Notice of Modification

Section 96(2) of the *Environmental Planning and Assessment Act 1979*

The development consent (SSD 5465) for the Chain Valley Colliery granted by the delegate for the Minister for Planning on 23 December 2013.

Figure 1: Chain Valley Extension Project – Development Application Area and Lease Plan (The Site)

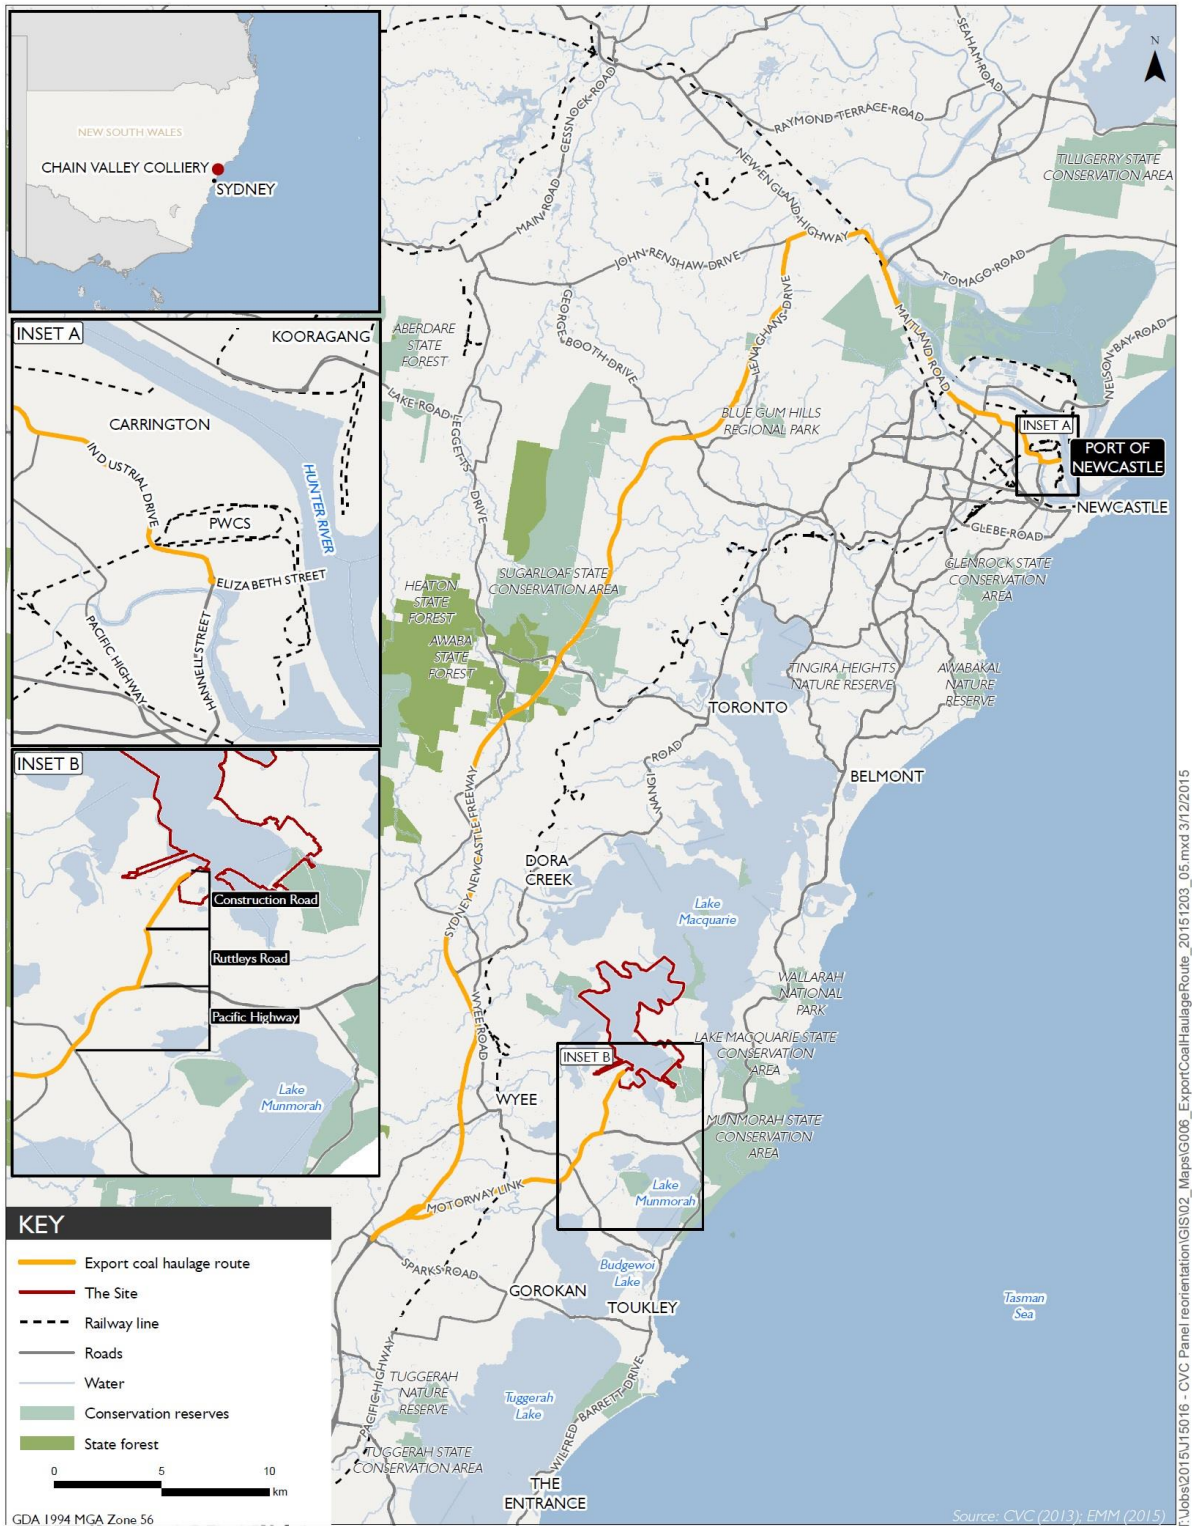
16. In Appendix 2, replace Figure 1 with the following:

Figure 1: Noise Receiver Locations

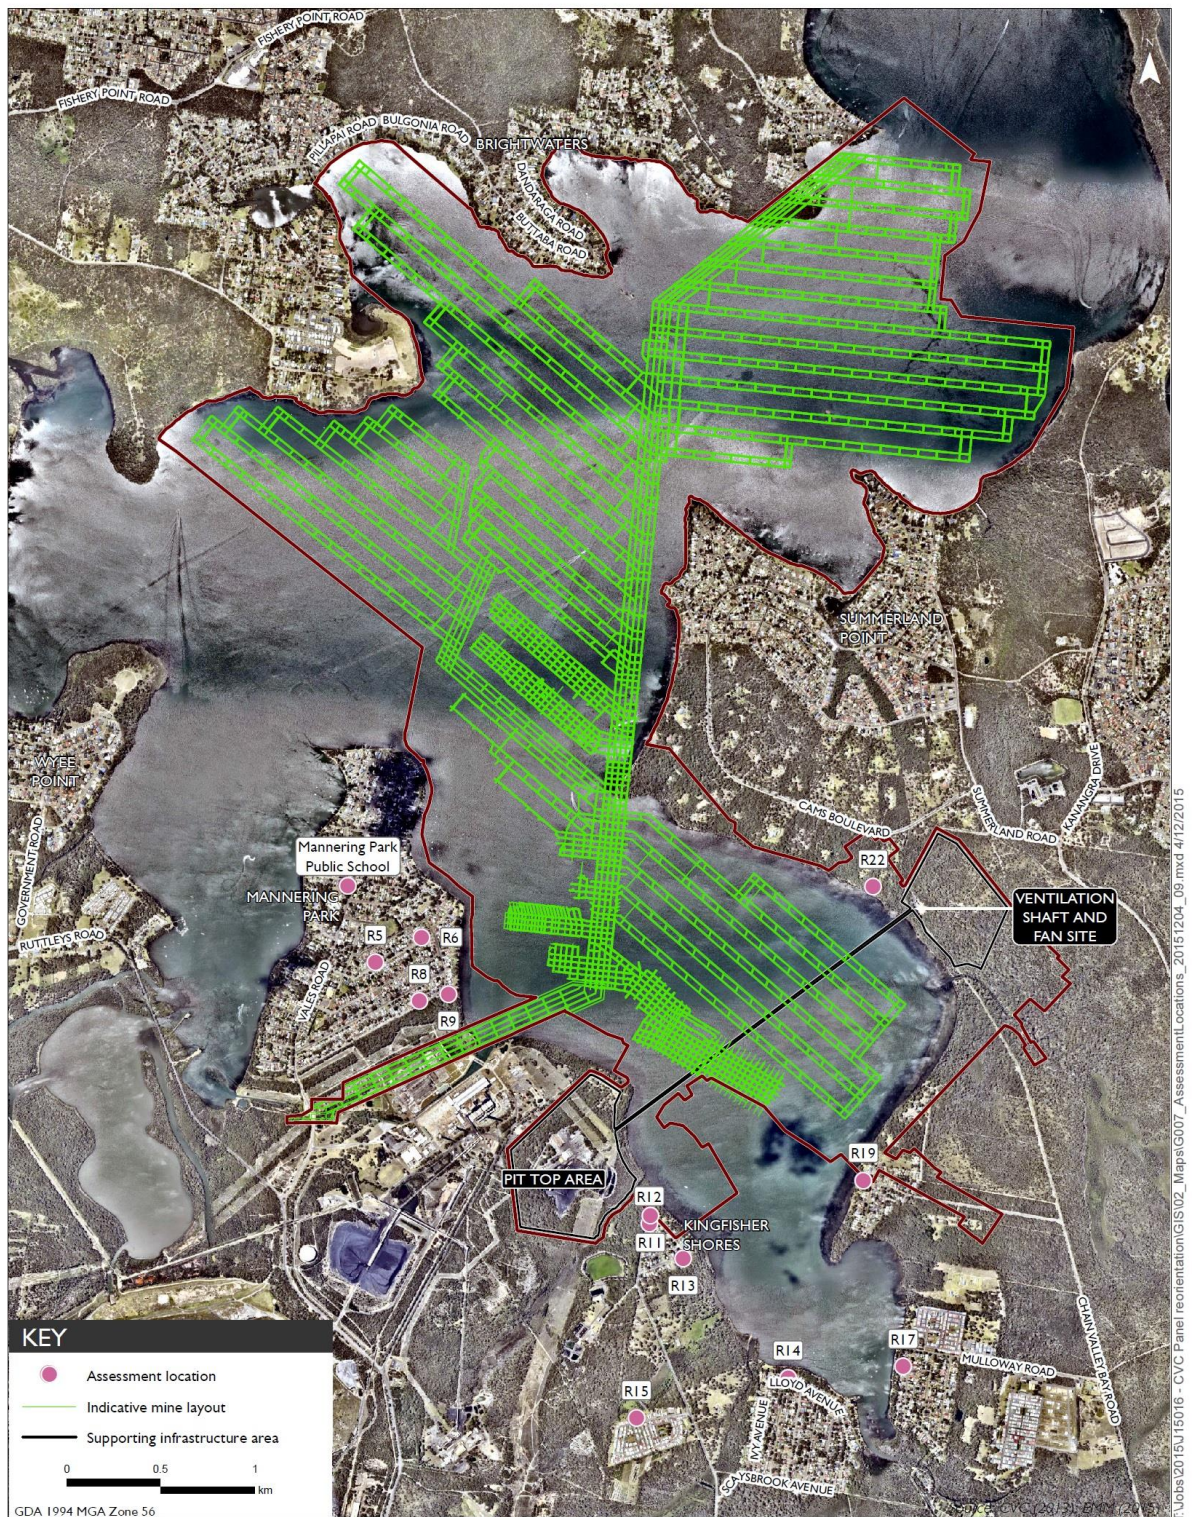
19. In Appendix 5, replace Figure 1 with the following:
